ADDENDUM #: 2

PROJECT NAME: TROY UNIVERSITY WRIGHT HALL REROOF

PROJECT NUMBER: DCM # 2026580 (SS&L PROJECT # 26092)

A02.81

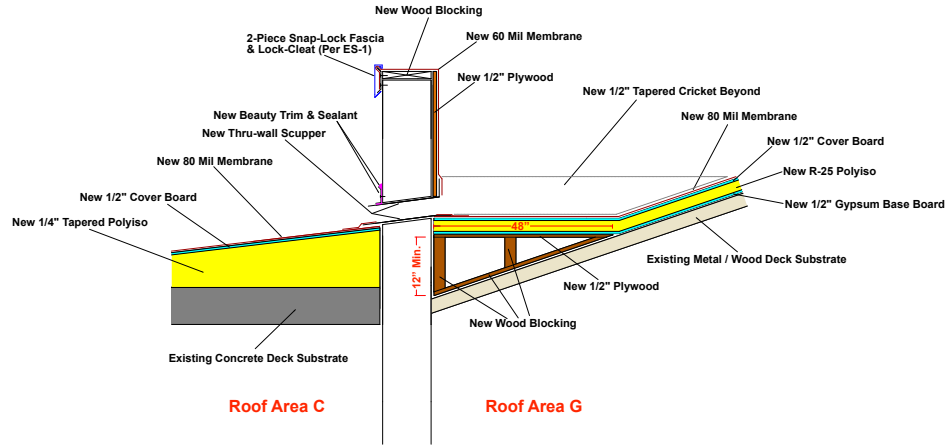
- There is no vapor barrier required over the steel (or wood) roof deck surfaces. A self-adhered vapor barrier approved by the roofing manufacturer will be required over all concrete deck components.
- See revised drawing on 5/A02.81

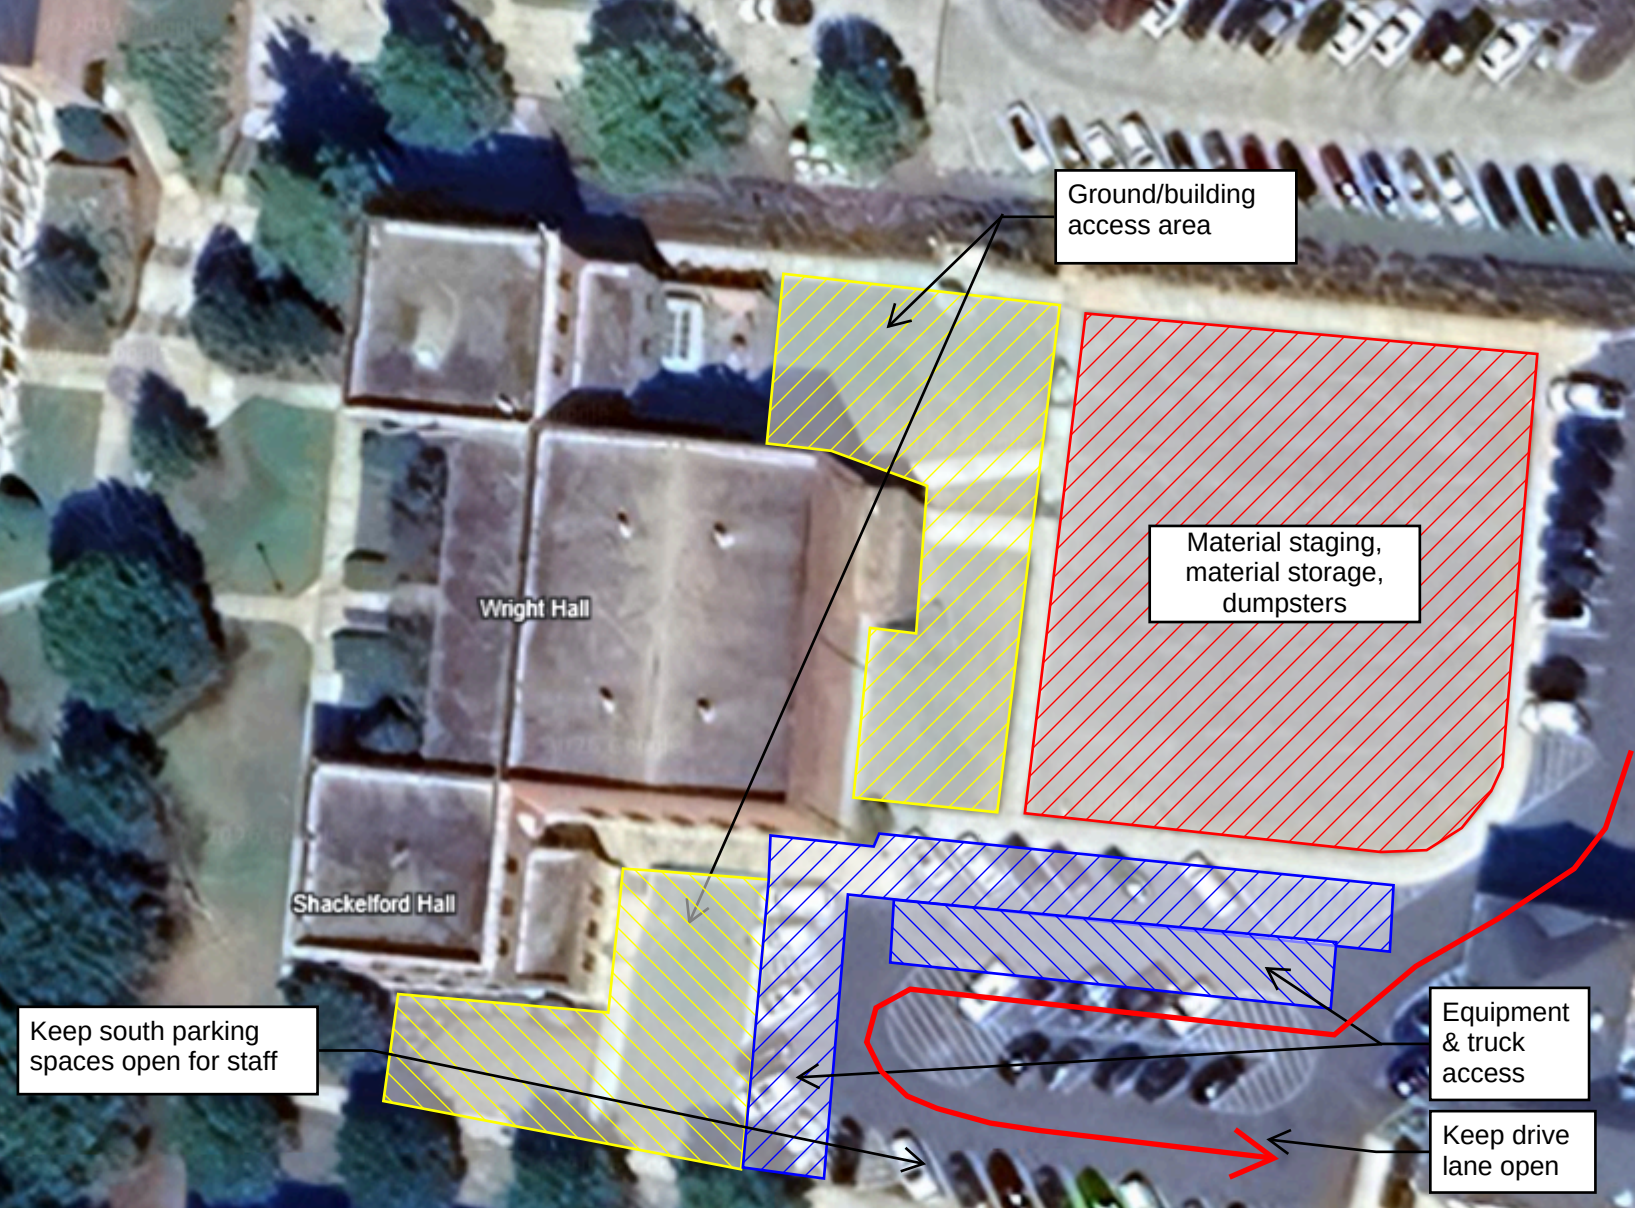
- Please see the marked-up site plan for site access and laydown areas.

Ground/building
access area

Material staging,
material storage,
dumpsters

Keep south parking
spaces open for staff

Equipment
& truck
access

Keep drive
lane open
